**NDACT Peer Reviewer Notes
Strada Jan 31, 2025 Application**

RE: Surface Water Review: CBM Caledon Pit/Quarry ARA Application
Aggregate Resources Act Application # 626600
St. Mary's Cement Inc. – CBM Caledon Pit/Quarry
Aggregate Licence for a Pit/Quarry Below the Ground Water Table
Lot 14, 15, 16, 17, 18, Concession 3, 4, Geographic Township of Caledon
Town of Caledon, Regional Municipality of Peel

**NDACT Peer Reviewer Notes
Strada Jan 31, 2025 Application**

RE: **Groundwater Review: CBM Caledon Pit/Quarry ARA Application**
Aggregate Resources Act Application # 626600
St. Mary's Cement Inc. – CBM Caledon Pit/Quarry
Aggregate Licence for a Pit/Quarry Below the Ground Water Table
Lot 14, 15, 16, 17, 18, Concession 3, 4, Geographic Township of Caledon
Town of Caledon, Regional Municipality of Peel
ECHO no. 1-234418384

Figure 1: Operational Phases

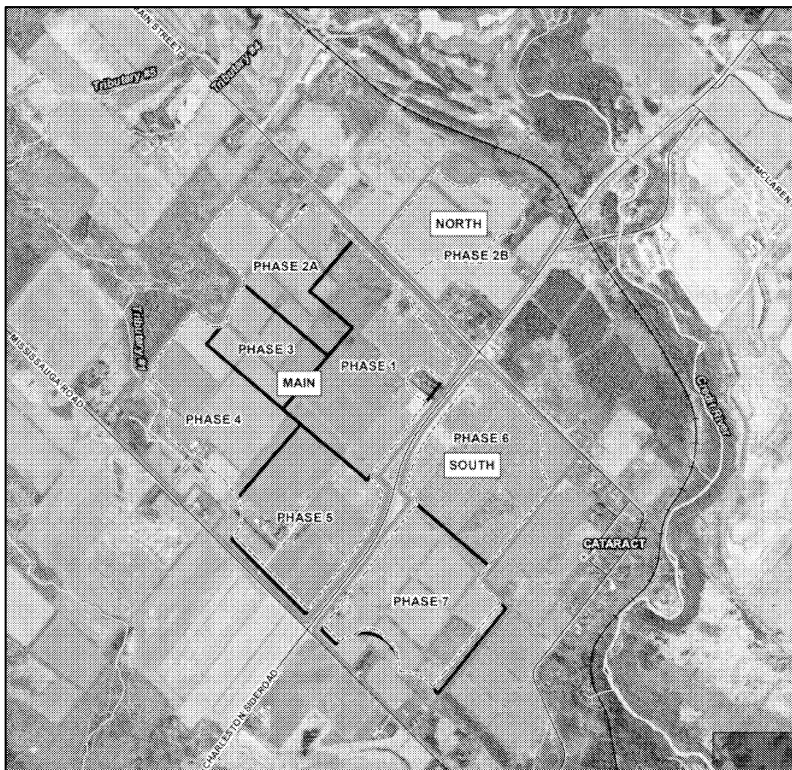
As shown in Figure 1 and noted in the Operational Plan (ARA Drawing No. 2 of 4), if approved, extraction of sand, gravel and bedrock below the water table would occur in three main areas over eight phases to depths of up to +30m. Aggregate extraction operations would begin in the Main Area, followed by the North Area and end

in the South Area. On-site operations would include a permanent processing plant (crushing, screening and wash plant) in the Main Area and an aggregate recycling area with access from Regional Road 24. A portable processing plant is proposed in the South Area. Extracted aggregate in the South Area would be moved to the Main Area through a proposed tunnel beneath Charleston Sideroad. See Figure 1.

Figure 2 Area Features

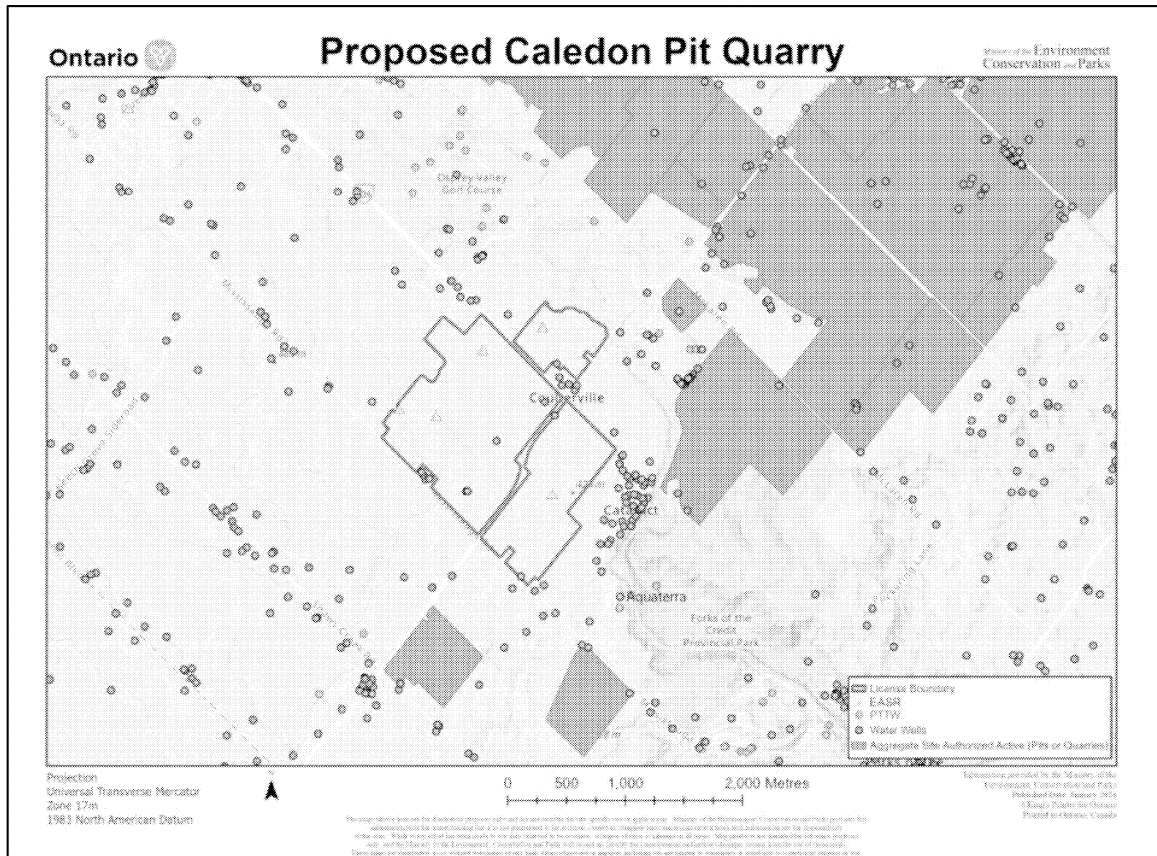
Figure 2 shows the location of existing wells, large water takings and authorized aggregate extraction sites in the area. The area is not serviced with municipal water and residents rely on private water supply wells. There are many wells within the Hamlet of Cataract, Hamlet of Coulterville and along Mississauga Road and Regional Road 136. Large water takings in the area consist of Environmental Activity Sector Registers (EASRs) and Permits to Take Water (PTTW). Several EASRs were registered on the Site for temporary water takings as part of the field investigations. Although many PTTWs are shown in Figure 2, there are only two active water takers within approximately 1km of the Site. Osprey Valley Golf Course is located northeast of the Site and takes water from several sources including a bedrock well, the Credit River and two irrigation ponds. Aquaterra Corporation

located south of the Site takes water from one overburden well for bottled water. The locations of authorized aggregate operators in the area are also shown in Figure 2 which Golder (2023a) report noted that all are operating as pits.
